# ENVIRONMENTAL REVIEW TEAM REPORT

## BURTON ROAD SUBDIVISION SALISBURY, CONNECTICUT

FEBRUARY 1979

FIGURE I.

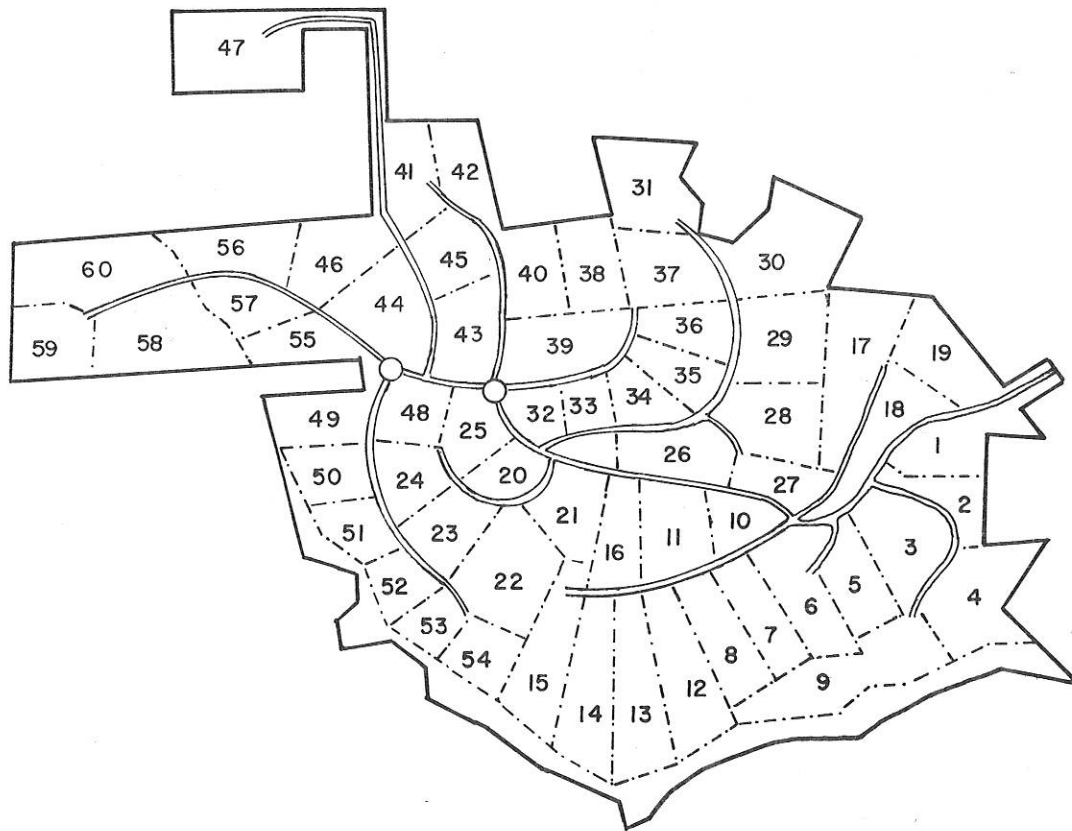
- . The section of Burton Road adjoining lot 10 should be considered for relocation 50-100' south of its present location in order to avoid excessive disturbance of the natural drainageway in that area.

- . The proposed plan indicates only one access point to the subdivision (Lincoln City Road). This could pose a safety problem during storm conditions and it is recommended that another access point be developed for emergency access only onto Upland Meadow Road.

- . The proposed private roads do not indicate any turn-arounds or back-arounds at their ends. It is recommended that back-arounds or turn-arounds be provided to preclude the need for emergency vehicles such as fire apparatus to back up and out onto the main road. It is also recommended that private roads in the vicinity of lots 32 and 20 and lots 44, 48 and 55 be aligned opposite each other on the public road for safety reasons.

- . Consider establishing a fire pond in the area of lots 18 and 19. This would benefit the entire community and also provide some additional storm water storage.

It is hoped that the proposed sedimentation pool in the vicinity of lot 19 will be a permanent structure. And that it will be maintained and cleaned out regularly. Consideration should also be given to designing the sedimentation basin for some temporary storm water storage. Design criteria and guidelines for constructing sedimentation and storm water control basins is available from the Litchfield County Conservation District.

To avoid excessive disturbance of the above mentioned natural drainageway, a relocation of Burton Road section 17+50 to 23+50 should be considered. A center-line shift 50' to 100' in a southerly direction would reduce necessary filling within the drainageway. The acreage of lot 10 would be reduced, but it would not be eliminated as a lot. It is recommended that the road be constructed with all erosion and sediment control practices complete before individual lot development begins. The engineering review of Burton Road Subdivision prepared for the Town by H. F. Mounier details additional concerns for this proposed road.

As mentioned earlier, there is only one access point to this subdivision via Lincoln City Road. This could pose a safety problem for the 60 lots during storm conditions. It is recommended that another access point be developed for emergency access only onto Upland Meadow Road through lot 30, 39, 41 or 42. This road could be gravelled and chained off to be used only in the case of an obstruction across the main subdivision road.

As proposed, the private roads do not indicate any turn-arounds or back-arounds at their ends. It is, therefore, recommended that back-arounds or turn-arounds be provided to preclude the need for emergency vehicles such as fire apparatus to back up and out onto the main road.

There appears to be two turn-arounds located in the vicinity of lots 44 and 48 and lots 39 and 25. Given the private roads entering the turn-arounds, it is recommended that if possible, they be used temporarily and replaced with street intersections. It is recommended that private roads in the vicinity of lots 32 and 20 and lots 44, 48 and 55 to be aligned opposite each other on the public road for safety reasons.

FIGURE 3.  
VEGETATION TYPE MAP

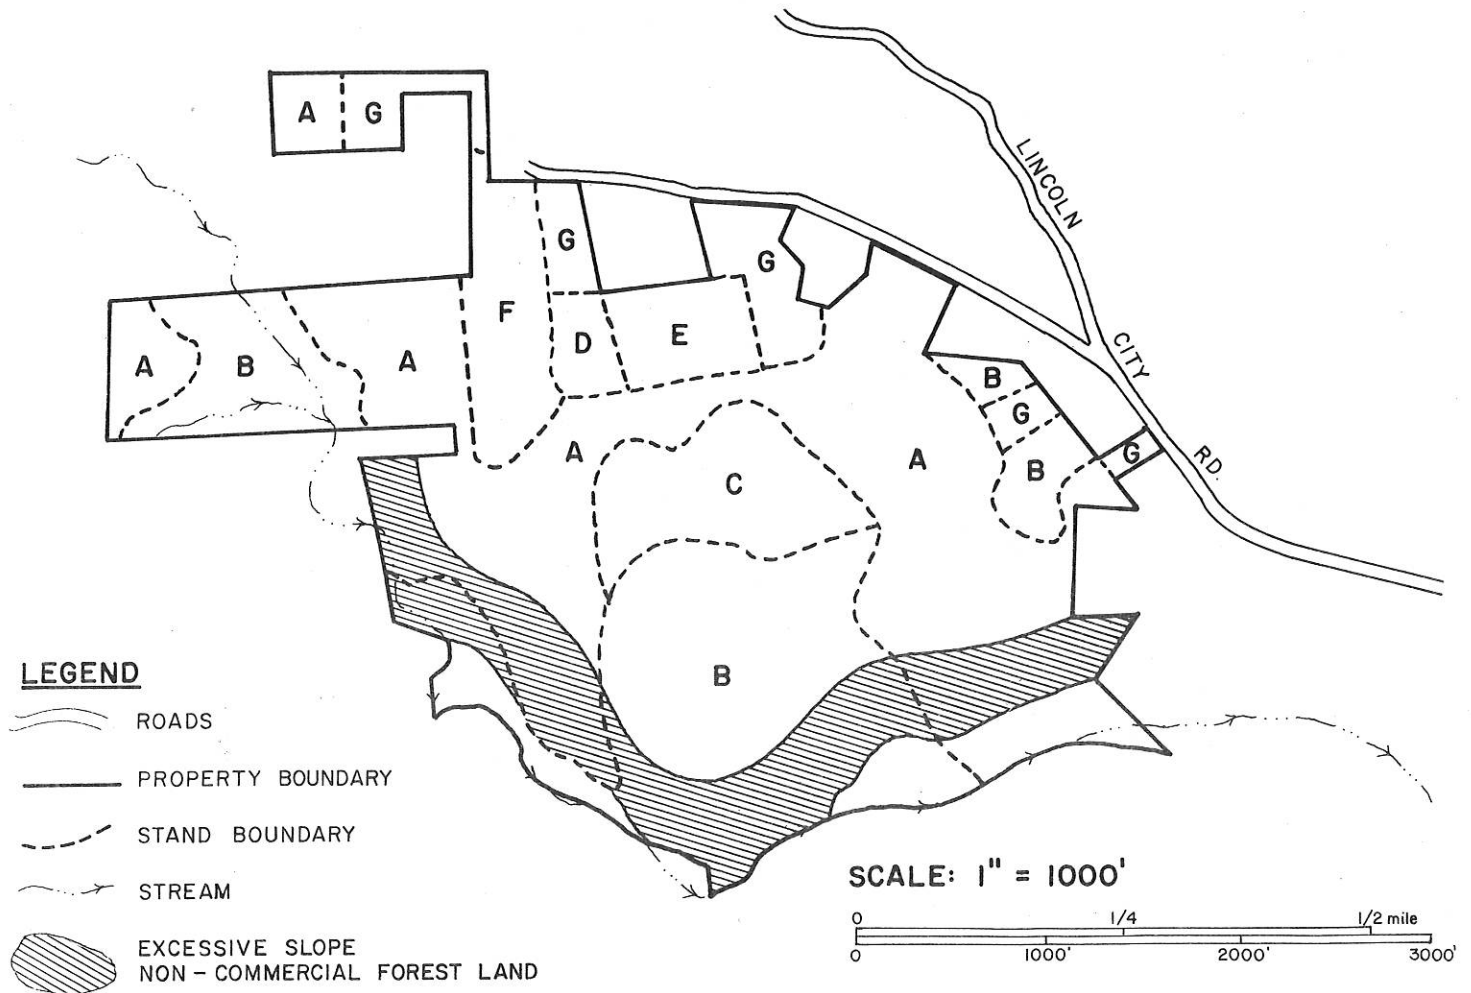
Intermediate thinnings of about 1/3 of the total volume (depending on crowding) in the fully stocked and over-stocked stands containing predominantly sawlog-size trees would, in several years, increase the health and vigor of such stands.

The gradual opening of the forest canopy in the hemlock stand produced by a light thinning of perhaps 1/5 of the total volume would help the trees to become more windfirm. This would also help to reduce windthrow hazards when and if the area is opened up for development.

The harvests in the hardwoods, softwoods-hardwoods, and hemlock stands should be concentrated on removing unhealthy, poor-quality and undesirable trees. Main haul roads should follow contour lines to reduce erosion problems and should coincide with planned subdivision roads wherever possible. If harvests were timed properly, tree tops left on the site could supply deer with browse for a year or two, lessening their dependence on desirable tree seedlings.
